Design Review Commission Report

Meeting Date: Thursday, April 7, 2016

Subject: **224 South Linden Drive (PL1600747)**
A request for an R-1 Design Review Permit to allow the construction of a new two-story single-family residence located in the Central Area of the City south of Santa Monica Boulevard. The Commission will also consider adoption of a Categorical Exemption, pursuant to the California Environmental Quality Act.

Project Applicant: Gabbay Architects

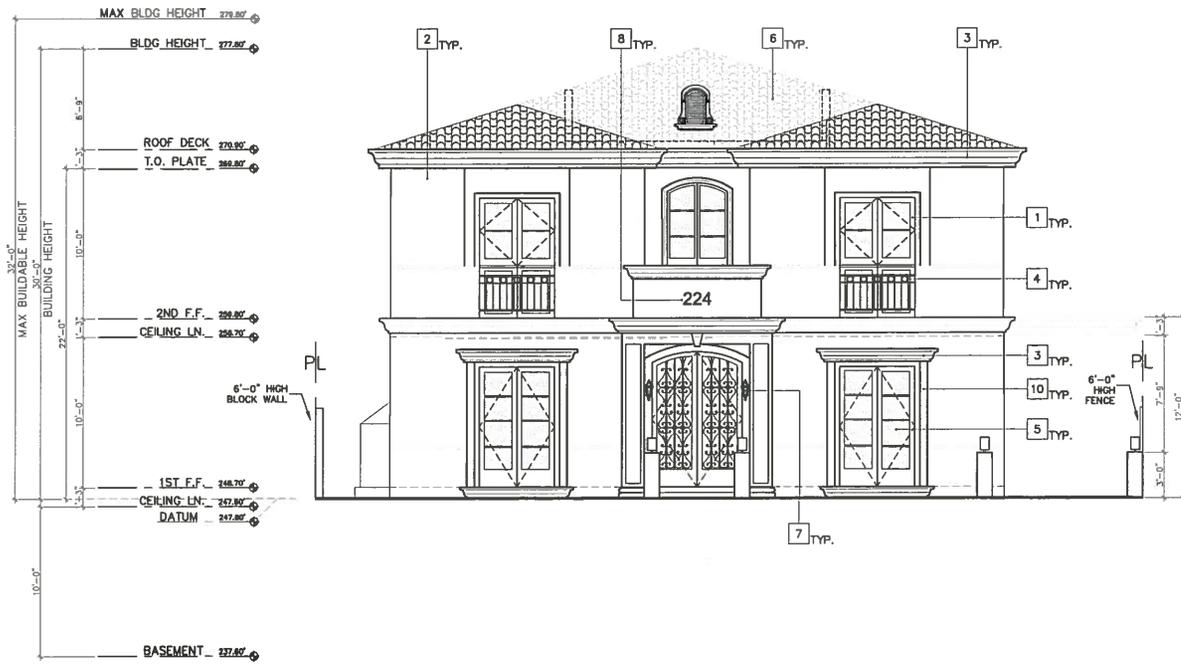
- Consider removing, or reducing in number, the pre-cast horizontal moldings that wrap the facade, which have been included in the redesign for the purpose of increasing the design's horizontality. Such additions create an undesirable busyness to the façade that detracts from the overall style.

- Consider reducing the size of the openings for the glazing, including the French doors and the window unit located above the entry, as refinement of these openings would have a more substantial impact on the perceived verticality of the facade. The applicant may wish to explore continuing the ground floor bulkheads and replacing the French doors with double casement windows, which would sit atop the bulkhead to better ground the building and thereby enhance the horizontality of the design.

- Review removal of the single dormer vent that has been added to the front portion of the roof. This element serves only to increase the design's verticality, drawing the eye upward, and does not promote the desired horizontal configuration.

- Continue to study the porte cochere by introducing a columnar element and eliminate the cantilever, which is a contemporary treatment that is in conflict with the more traditional, Mediterranean style.

- Further study the keyhole design proposed at the second floor balconies in relation to the traditional styling of the residence. The applicant may wish to also explore the incorporation of arched balcony openings or consider the introduction of a header for these areas, which would be more indicative of a Mediterranean style. Additionally, the applicant may wish to reconsider the metal treatment at the railings and incorporate a more traditional, and less contemporary, pattern into these elements.
